**Re: Dutch Bros  
Paseo Del Norte & Universe  
90-Days Temporary Certificate of Occupancy  
Transportation Development Final Inspection  
Architect's Stamp dated 10-7-21 (B10-D003I)  
Certification dated 6-16-22**

Dutch Bros  
NEQ Paseo Del Norte & Universe  
Albuquerque, NM 87114

Site Plan

C-100

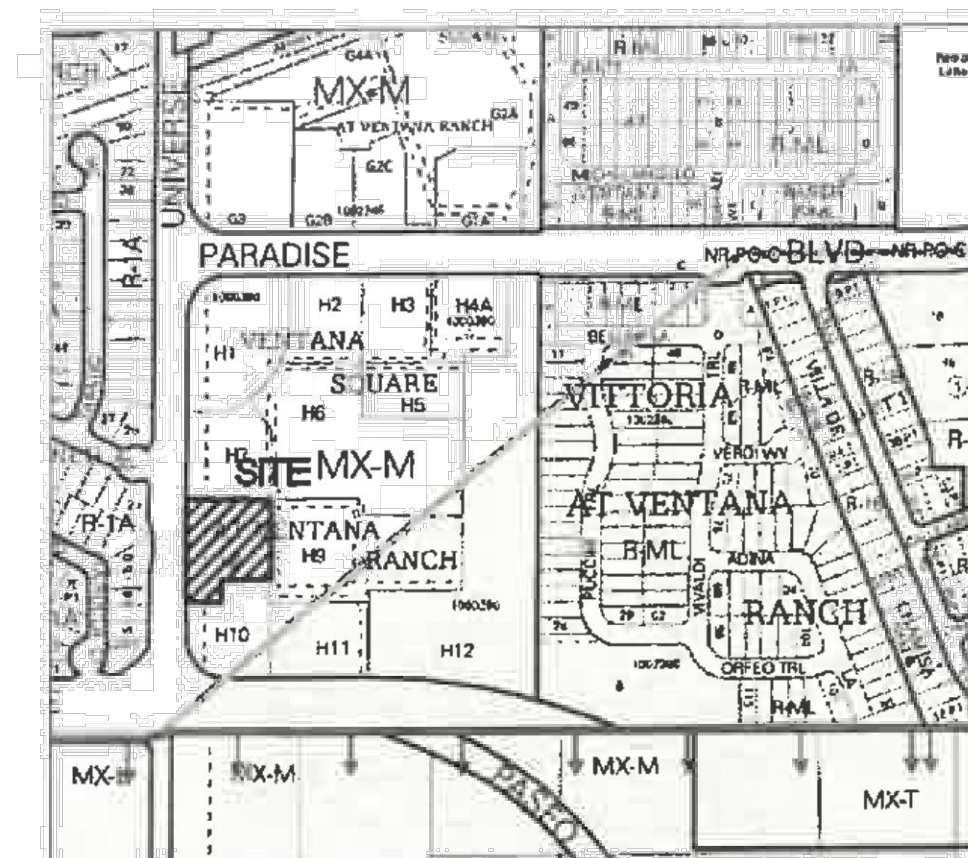
These barricades not installed since the Dions Development is currently under construction and the construction fence is blocking traffic. Dions should be open in approximately two months.

CONDITION OF FINAL C.O. APPROVAL:  
① WORK ORDER CPN 670982 BE BUILT/ CONSTRUCTED AND APPROVAL BY COA  
② TRACT H-7A (DIONS - NM122) BUILT APPROVED AND FINAL C.O. APPROVED.

This curb cut has been removed in order to allow the future Development to decide where to locate their connection. Barricades not installed.
